Subject: Parachute and Actuators Being Presently Tested at
El Centro

SUBJECT: PARACHUTE & SEAT TEST PROGRAM - EL CENTRO

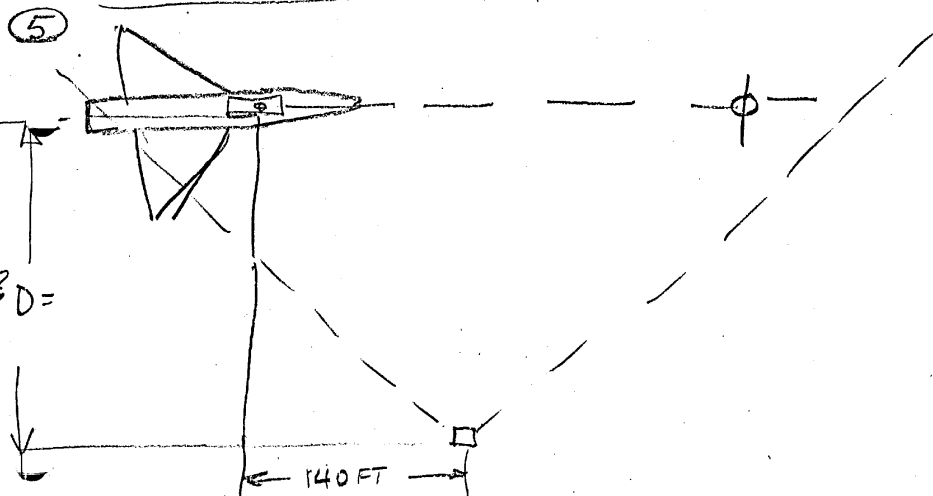
- ① TRAJECTORY CAMERA'S - (2) FIXED. 1.- FLASH BULB FOR TIME ZERO. 2.- No TRUCKS/VEHICLES IN VIEW.
 (340' X 400' HIGH) 200 FRAME/SEC? 20 F/S HULCHER?

1ST Static Ejection Seat Test

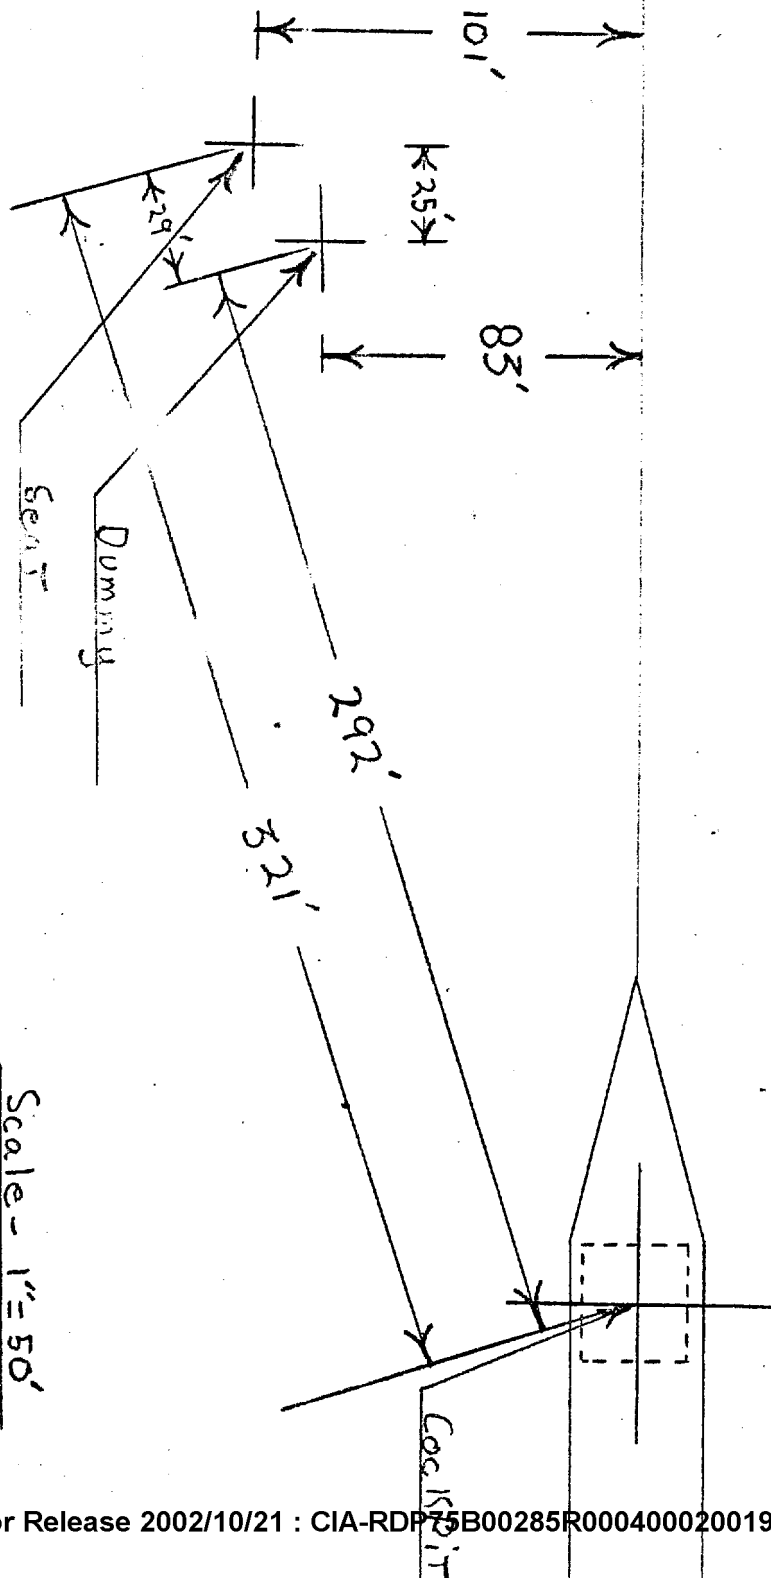
Estimated Dummy Height

(From Movies) = 300 (77)
